RESPONSE TO REQUEST FOR ADDITIONAL INFORMATION

APR1400 Design Certification

RAI No.: 398-8457

SRP Section: 15.06.05 – Loss of Coolant Accidents Resulting From Spectrum of Postulated Piping Breaks Within the Reactor Coolant Pressure Boundary

Figure 1 Core flush by hot side injection

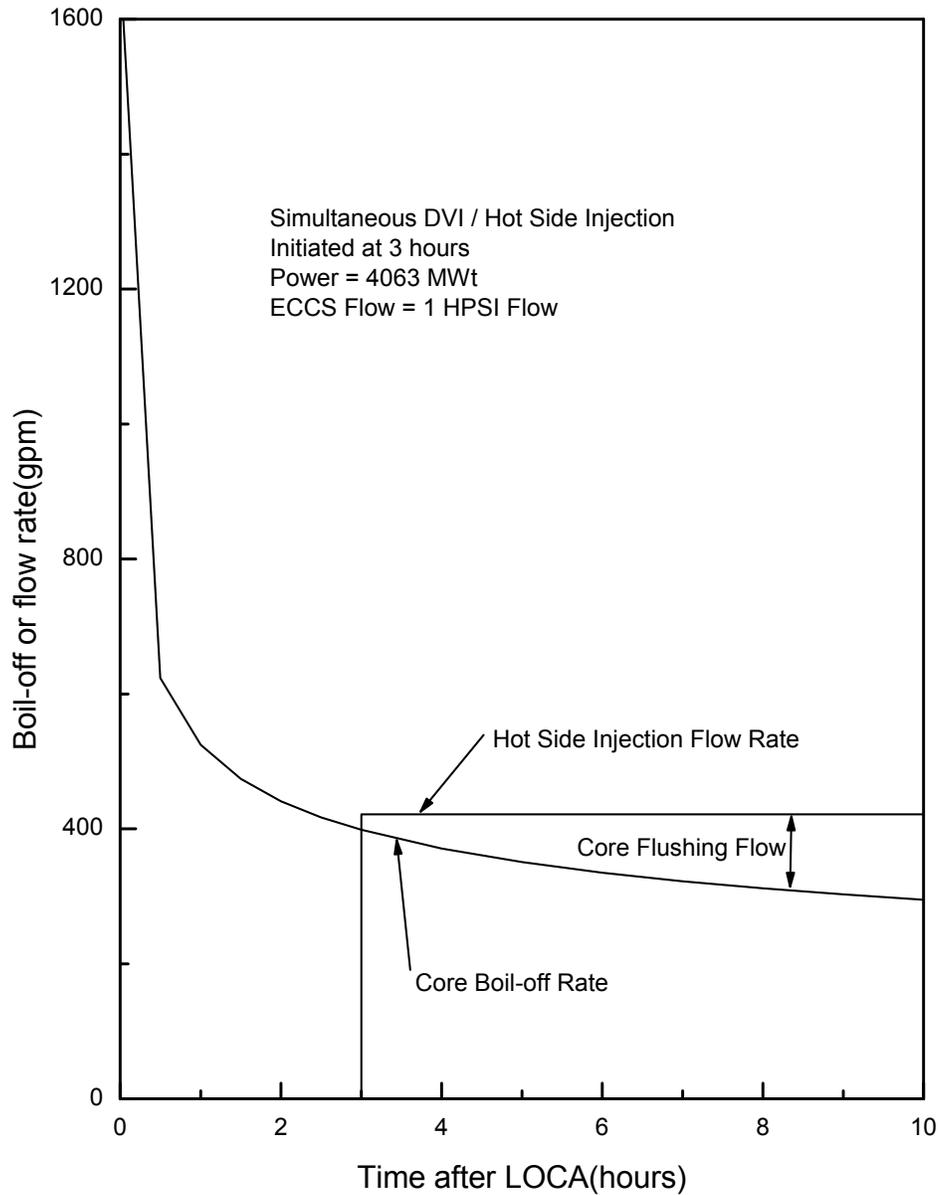
2. The analysis does not appear to account for reduced injection flow during the switchover to hot leg injection at 3 hours (Section 3.5.4). Is there a reduced flow during this transition period and how is it addressed in the calculation?

The injection flow is not considered to decrease during the switchover to hot leg injection. Instead, the injection flow is assumed conservatively. The flushing flow rate is calculated by hot side SI injection flow and core boil off rate as shown in Fig.1. Even though 2 SI pumps actuate during the switch over period, it is assumed that 4/10 of the total flow from a single SI pump enters the reactor vessel from the hot leg and all of the decay heat from the core boils off liquid. At 3 hours, core flushing flow is decreased to 23 gpm. After 3 hours, as the core boil off rate has decreased, the core flushing flow has increased. The flushing flow rate is used to compute the boric acid concentration in the core.

Figure 5. Inner Vessel Boric Acid Concentration vs. Time

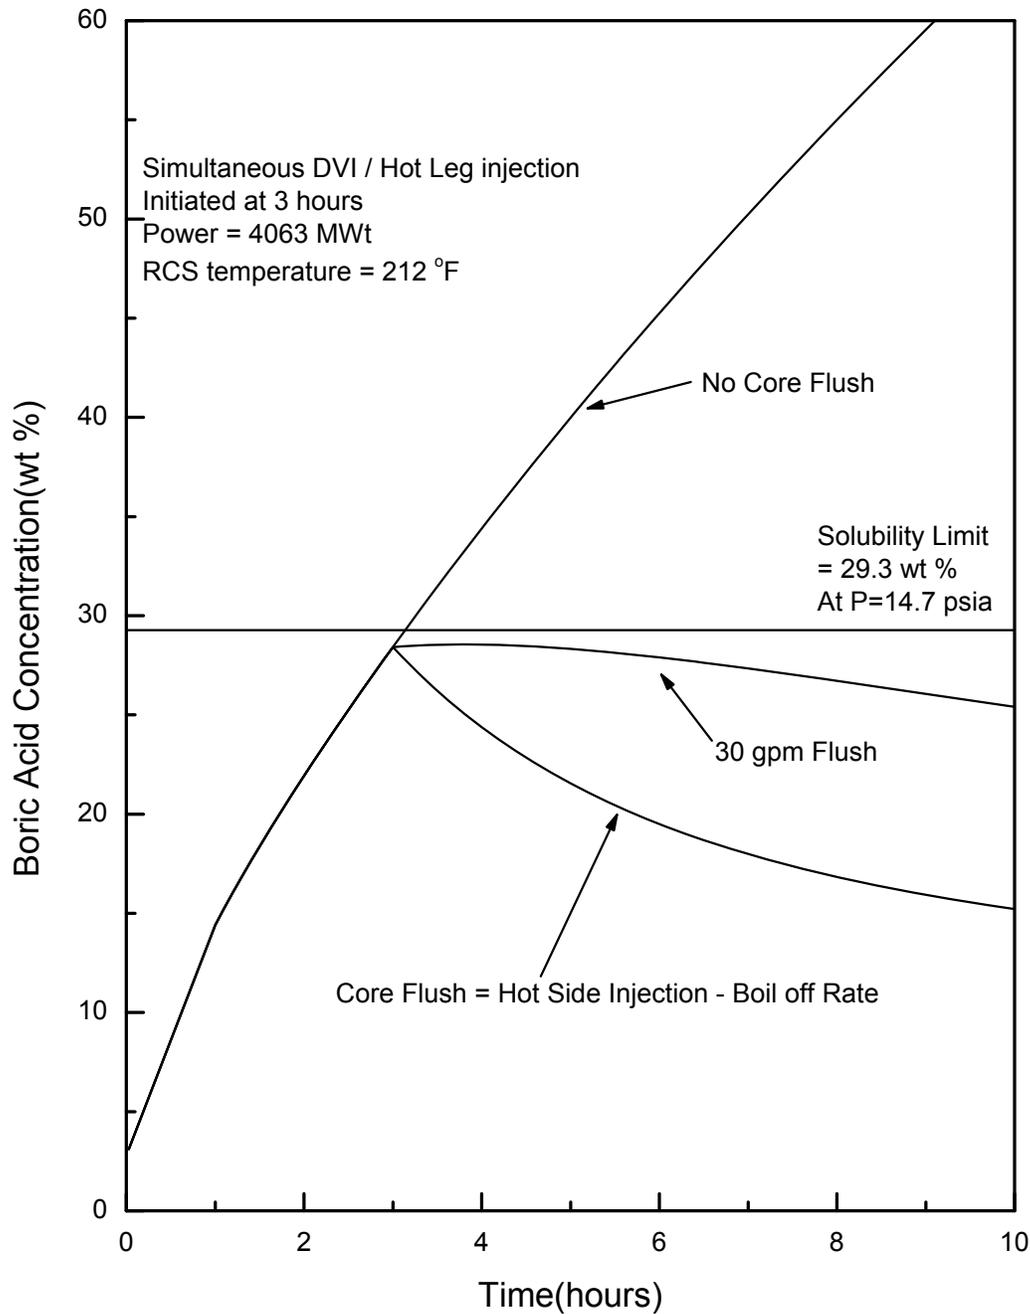
13. Figure 4-3 shows the buildup of boric acid concentration which depends on the boiloff rate and appears to be independent of break size? For smaller breaks where natural circulation is mixing the coolant, the switch to hot leg injection could possibly hinder the natural circulation by introducing cold liquid into the hot side of the natural circulation loop. How does the approach used address this possibility?

The double ended cold leg break size is the limiting break for long term boric acid accumulation in the inner vessel region, because the largest amount of coolant with high boron concentration is added to the inner vessel from SITs and SI pumps. Therefore, only the double ended cold leg break size is considered to calculate boric acid concentration by the BORON code. Thus, the boric acid concentration for the double ended cold leg break size is depicted in Figure5.

The mixing volume for computing the boric acid concentration is changed to include the additional volume from the top of the core to the top of the hot leg piping at the RV outlet nozzles. If the water level in the inner vessel is higher than the top of hot leg, boron precipitation is not a concern. Natural circulation is not considered in the BORON code because natural circulation begins when injected water refills to the top of the steam generators, in the case of smaller break sizes.

Even though the switch to hot leg injection could possibly hinder the natural circulation by cold water; boron precipitation does not occur around the top of the core. Thus natural circulation is not addressed in the BORON code.

Figure 6. RCS Pressure after Refill vs. Break Area

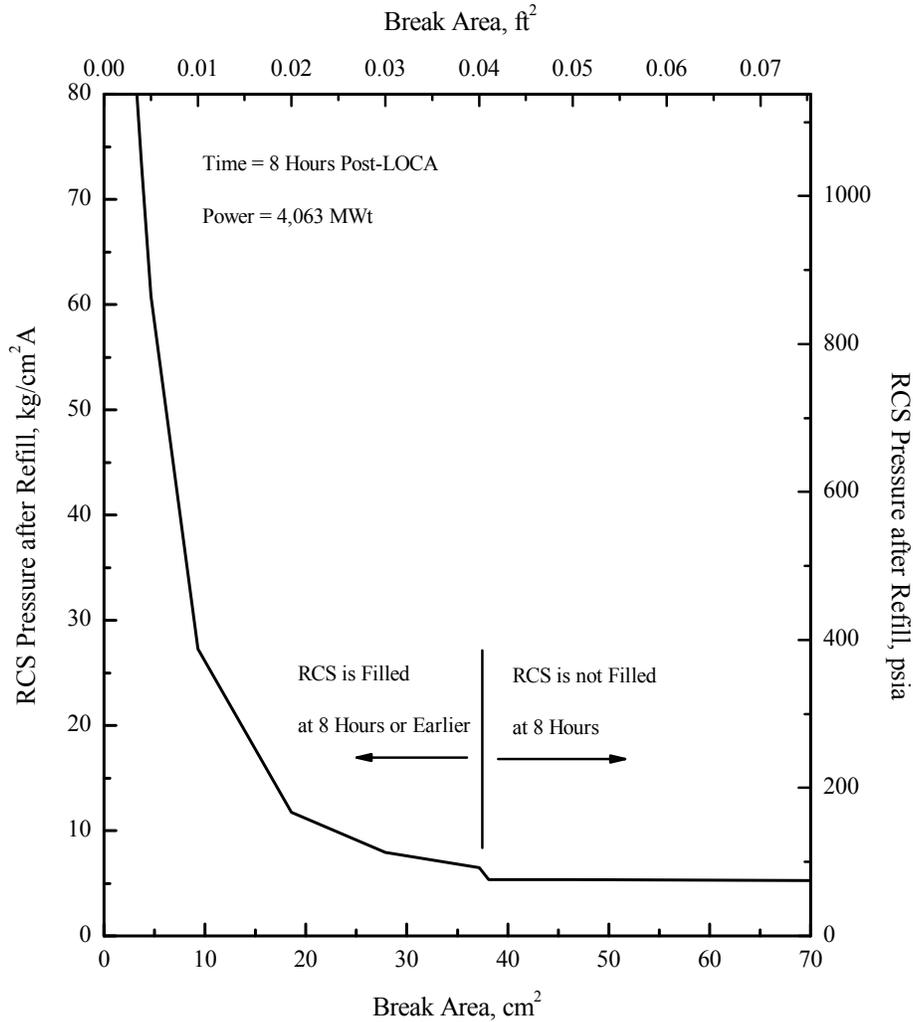
14. In the CENPD-254 methodology, the maximum break size for the small break analysis is determined by the auxiliary feedwater capacity. There is no mention of auxiliary feedwater capacity in the technical report. How was the upper limit size determined for the small break?

The decision time at which the operator decide whether to use the large break procedure or the small break procedure in order to continue the cooldown of the RCS. This time (8hr) is determined between the earliest time at which the SDC entry conditions can be achieved, and the latest time for which auxiliary feedwater can be assured to be available.

In order for the SDC system to be used to remove heat from the RCS, there must be sufficient liquid in the hot leg from which it takes suction. If RCS is refilled before the decision point time, the break case is assured of having sufficient coolant in the RCS to use the SDC system. Thus, the decision time determines the upper limit size of small break for which the SDC system can be used. This break size is 0.04 ft² as is shown in Figure 6 below.
